## CONFIGURATION CHANGES AND CERTIFICATION STATUS

Orbiter 01/09/03

### Left OME Pitch Clevis Mount Machined by MR Action in Order to Attach Pneumatic Pack:

### FRCS Dynatube B-nut Retainers Installed by MR: (Cont)

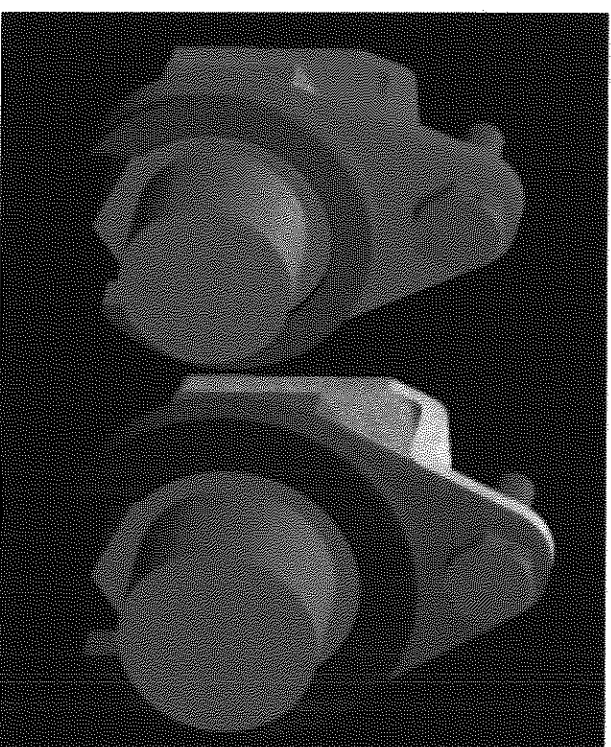
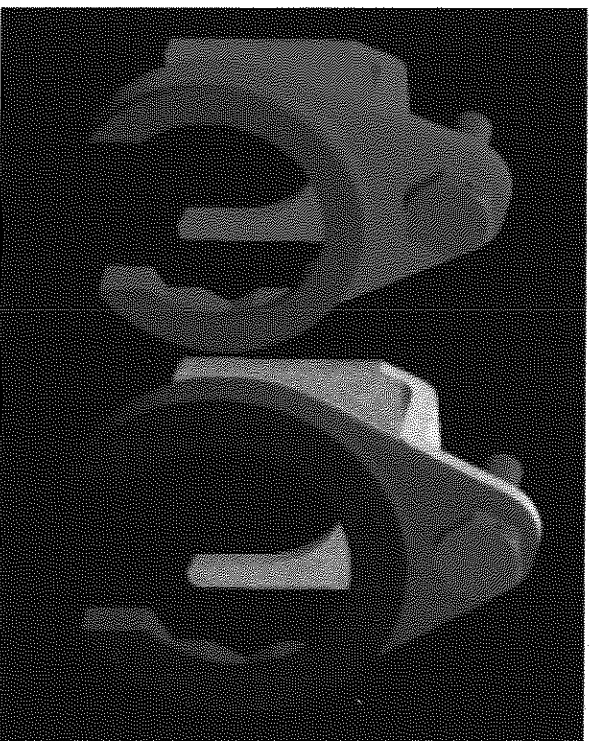
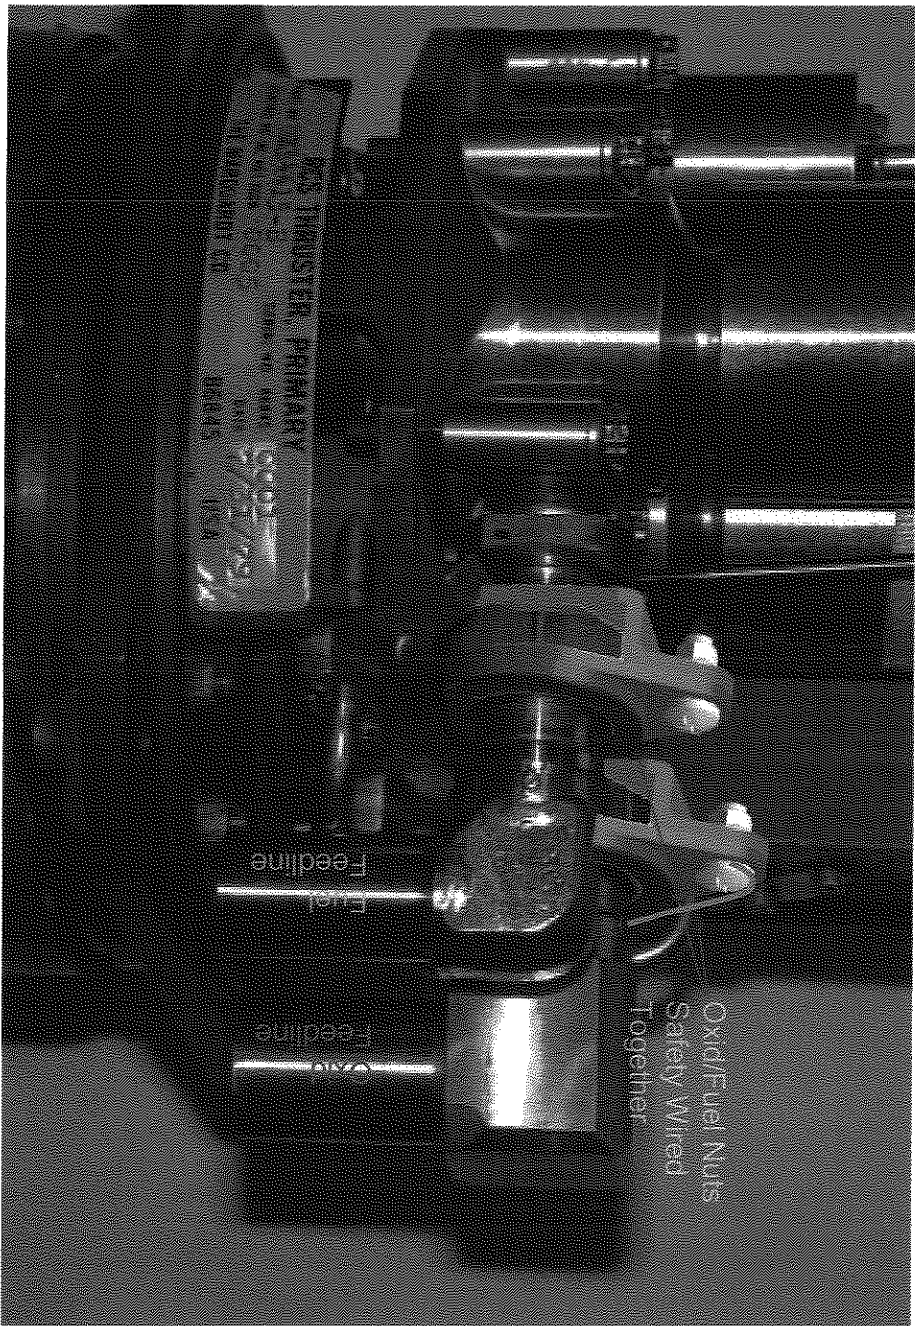
Approximate Dimensions: 2" height

1.5" width

0.65" depth

Weight of Assembly: 1.8 oz oxid, 1.45 oz fuel

Material: CRES 304

Bolt: NAS1003-2H

Nut: MD114-1001-0104

### OME Pitch Clevis Mount (Actuator Not Installed)

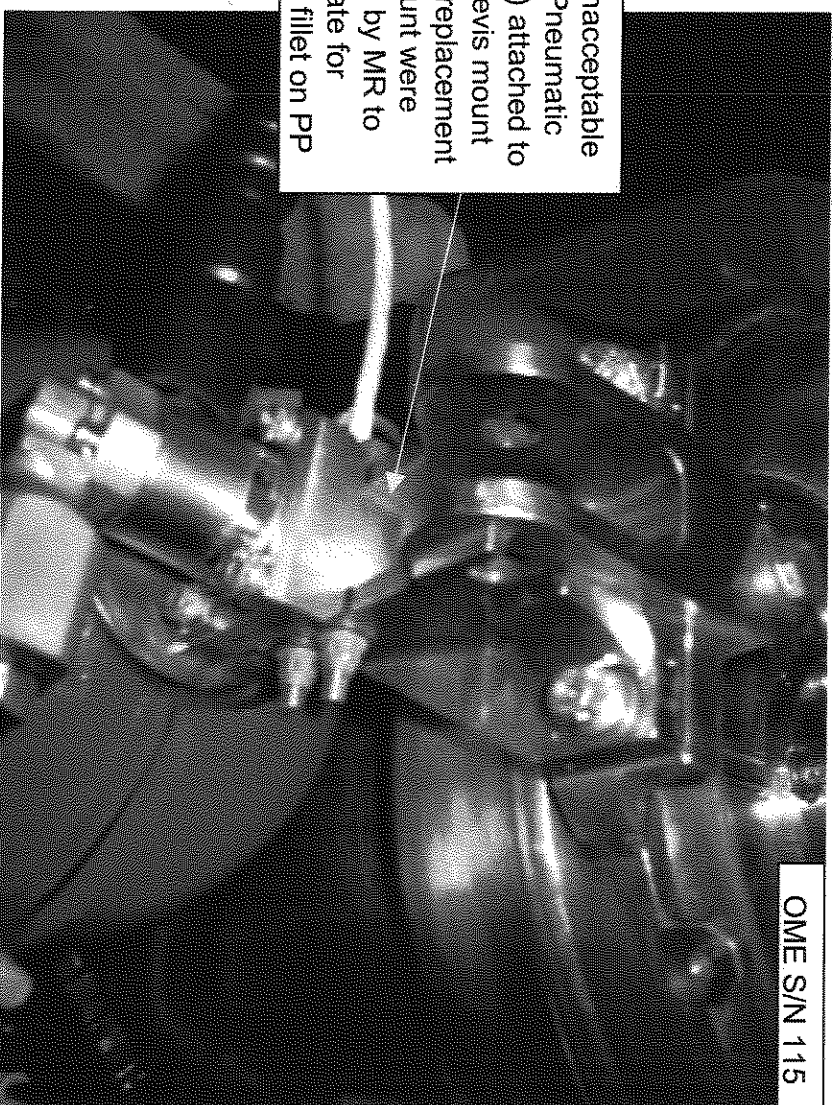
- Area of unacceptable gap with Pneumatic Pack (PP) attached to original clevis mount
- Tangs of replacement clevis mount were machined by MR to compensate for oversized fillet on PP

- Plan was developed to machine clevis tangs to compensate for oversized fillet (chamfer 0.08" off edges)
- Boeing/JSC Stress verified integrity of the clevis mount is not adversely affected
  - Chamfer does not protrude into bolt holes
- Measurements of both the removed part and the replacement part verified acceptable difference in pitch actuator mounting hole location without adjustment of actuator
- Travel and Response and Heat Shield Clearance checks were performed during OMS/RCS Flight Control Checkout (OMI V1238) with no anomalies

## Modified (Chamfered) OMS Engine Pitch Clevis

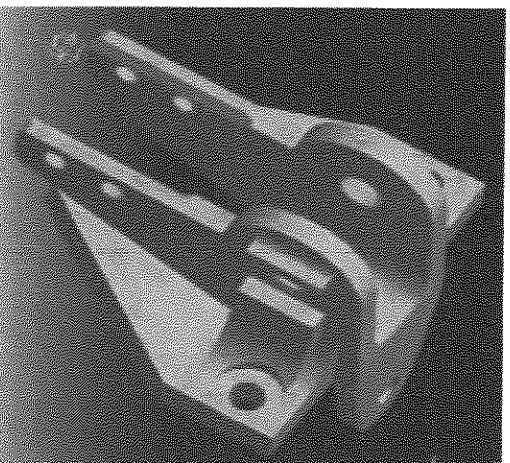
Top view of pitch clevis modification  
OMS engine S/N 116
